APPLICATION NO.	FILING DATE	FIRST NAMED INVENTOR	ATTORNEY DOCKET NO.	CONFIRMATION NO.
10/674,255	09/29/2003	Yuichi Iwase	09792909-5694	1727
26263 7590 12/09/2009 SONNENSCHN NATH & ROSENTHAL LLP P.O. BOX 061080 WACKER DRIVE STATION, WILLIS TOWER CHICAGO, IL 60606-1080				
EXAMINER				
HON, SOW FUN				
ART UNIT		PAPER NUMBER		
1794				
MAIL DATE		DELIVERY MODE		
12/09/2009		PAPER

Office Action Summary

DETAILED ACTION

Fig. 12

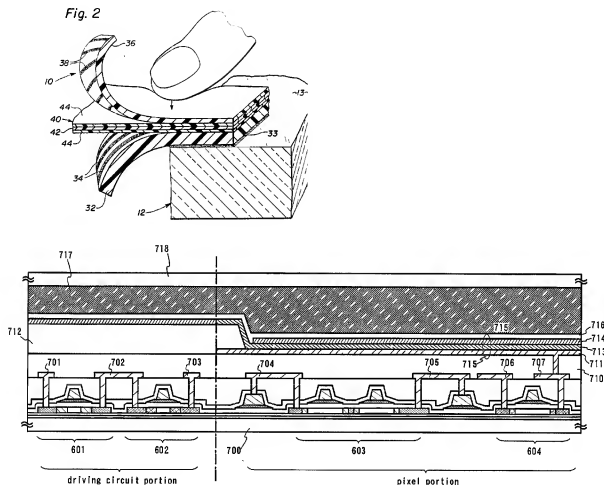
Yamazaki teaches a display panel in Fig. 12, shown on a following page, comprising a plurality of light emitting display devices, including a substrate on which the plurality of display devices are formed (light-emitting elements, [0202]), and a protective film formed directly on both the (a) substrate and (b) the plurality of display devices for protecting and isolating the plurality of display devices (light-emitting elements sealed between the substrate and a cover member, [0202], cover member

718, [0218]), wherein each of the plurality of the display devices has an organic light emitting layer made of organic electro luminescence material ([0202]).

Regarding claim 6, Yamazaki teaches that each respective display device is an organic light emitting device ([0202]) which includes an organic light emitting layer 713 between a first electrode 711 which is an anode (pixel electrode, [0212], anode of a light-emitting element, [0209]) and a second electrode 714 which is a cathode ([0214]) wherein the lights generated from the organic light emitting layer is extracted from the

second electrode side (anode 711 to organic light emitting layer 713 to cathode 714, Fig. 12).
